1 Amendments to the Drawings:

1 **REMARKS:**

Fig. 2

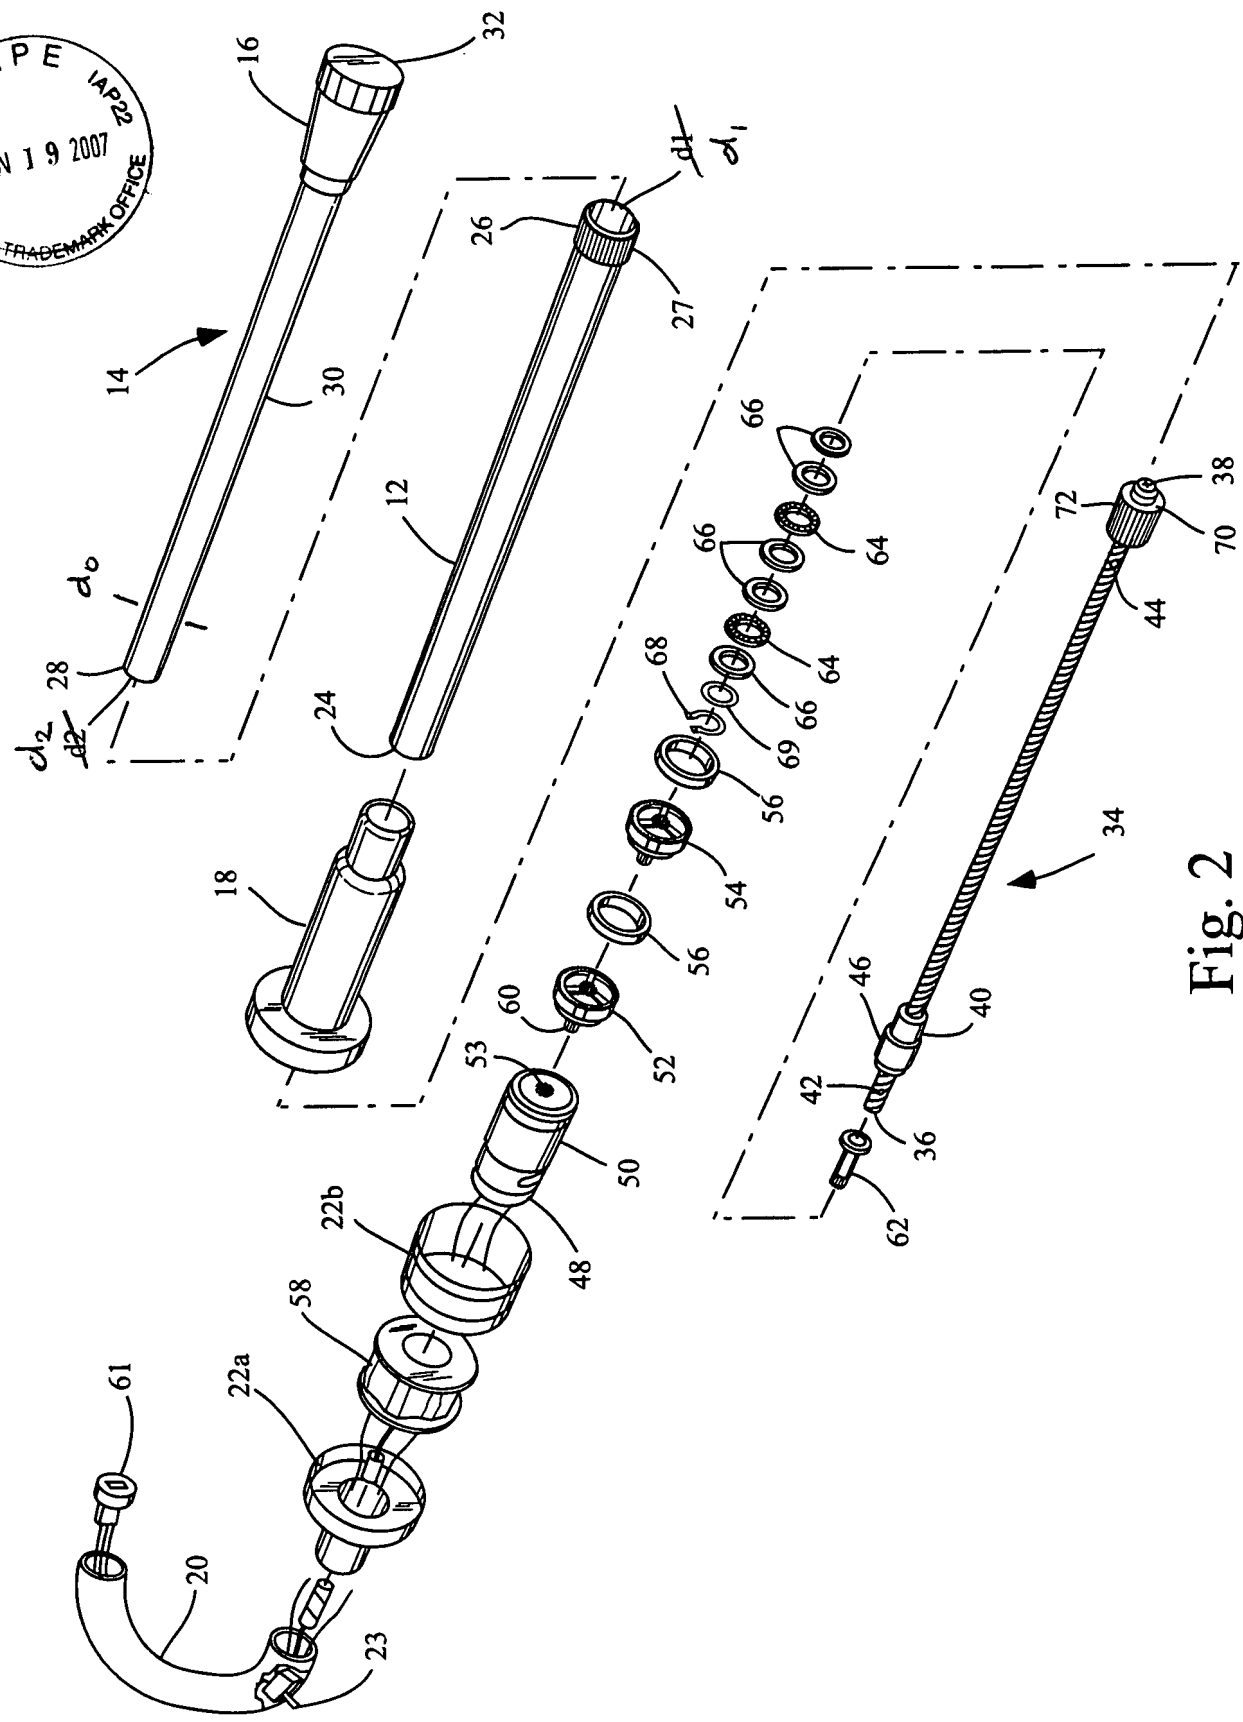
13 The Examiner objected to the drawings because they did not include a reference symbol
14 for outside diameter d_o which is mentioned in the description. A replacement sheet for Figure 2
15 is submitted herewith which shows outside diameter d_o . In addition, reference numbers
16 originally indicated as d_1 and d_2 have been respectively changed to d_1 and d_2 to be consistent
17 with the description.

2 Corrections have been made to Figures 2-3 as required by the Examiner. Figure 2 has
3 been corrected to add the reference d₀. Figure 3 has been corrected to delete reference characters
4 12', 14', 16' and 18' which are not mentioned in the description. It should be noted that although
5 the Examiner objected to the inclusion of reference character 10' on the grounds it did not appear
6 in the description, Applicant directs the Examiner's attention to page 2, line 17 of the description
7 which states "Figure 3 shows an embodiment 10' . . ." Replacement sheets are enclosed for
8 Figures 2 and 3, as well as annotated sheets for Figures 2 and 3 showing the corrections.
9
10
11
12
13
14
15
16
17
18
19
20
21
22
23
24
25
26

Fig. 3

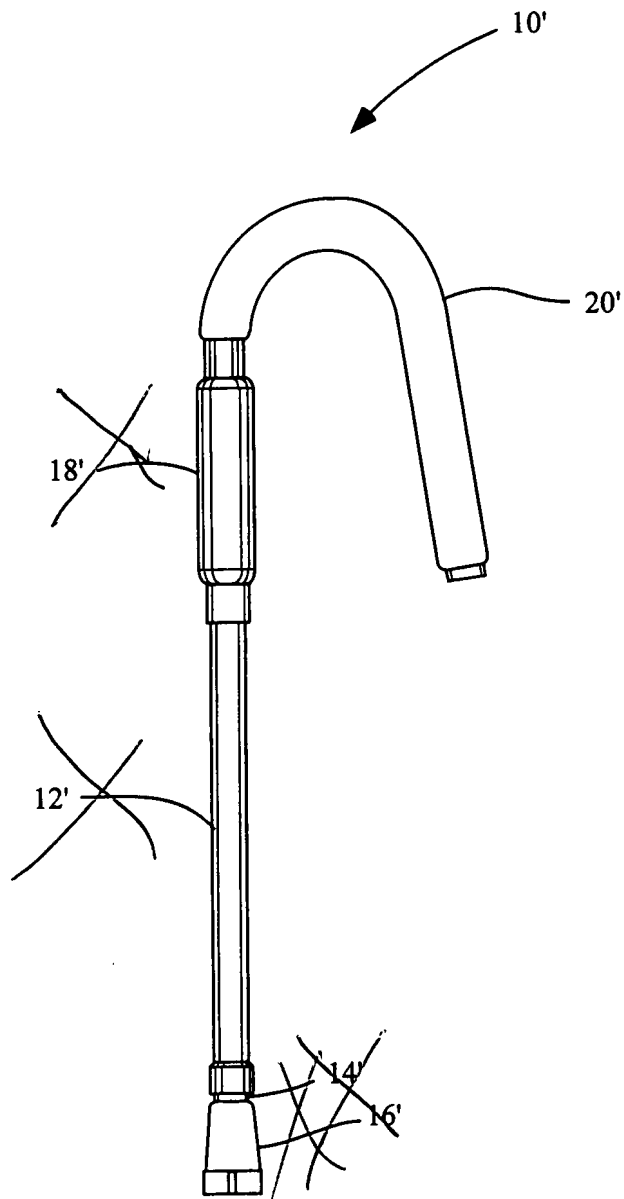
18 The Examiner objected to the drawings on the grounds that the drawings, specifically
19 Figure 3, included the following reference characters not mentioned in the description: 10', 12',
20 14', 16' and 18'. It should be noted that although the Examiner also objected to the inclusion of
21 reference character 10' on the grounds it did not appear in the description. However, page 2, line
22 17 of the description states “Figure 3 shows an embodiment 10' . . .” Reference character 10'
23 has therefore been left on Figure 3.
